# Work Order ID 77534

Item Name: Crosstube Aft

DRAWING NO. D412-664-243	TITLE CROSSTUBE ASSEMBLY (412 HI AFT)	REV. E	DART AEROSPACE LTD ENGINEERING ORDER		D.E.O. NO. D412-664-243-E-1	SHEET NO. SHEET 1 OF 2	SCALE NTS
DRAWN	CHECKED	MFG. APPR.	APPROVED	DE APPR.			
DATE 11.03.31	DATE 11/03.31	DATE 11.03.31	DATE 11/03.31	DATE 11.03.31

DRAWING NO. D412-664-243	TITLE CROSSTUBE ASS'Y (412 HI AFT)	REV. E	DART AEROSPACE LTD ENGINEERING ORDER		D.E.O. NO. D412-664-243-E-2	SHEET NO. SHEET 1 OF 1	SCALE NTS
DRAWN <i>MP</i>	CHECKED <i>ASS</i>	MFG. APPR. <i>RE</i>	APPROVED <i>MP</i>		DE APPR. <i>MP</i>		
DATE 11.09.07	DATE 11.09.19	DATE 11.09.19	DATE 11.09.19		DATE 11.09.19

CRUSHING OF D412-664-243

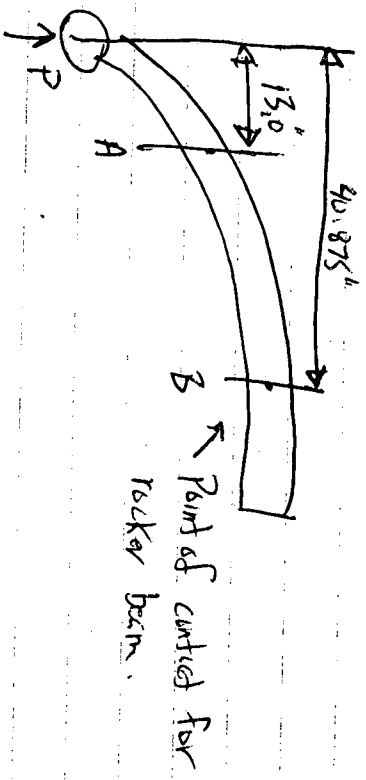
Acceptability of 8% CRUSHING AT END OF BEND

Point A:  $\omega_1 = 2.961$ ,  $\omega_2 = 2.522$

$$\text{CRUSHING} = (2.961 - 2.522) / (2.961 + 2.522) = 8\%$$

$$I = 1.676 \text{ in}^4 \text{ (from AutoCAD)}$$

Point B:  $\omega_1 = 3.357$ ,  $I = 4.613 \text{ in}^4$

$$A: F = M_c / I = P \times 13 \times 2.961 / 2 \times 1.676 = 11.484 \cdot P$$

$$B: \quad \quad \quad = P \times 40.875 \times 3.357 / 2 \times 4.613 = 14.651 \cdot P$$

$$M.S. = 14.651 / 11.484 - 1 = 0.27$$

Tube will break at rocker beam contact before area of 8% crushing, 8% crushing in area at end of the bend is acceptable
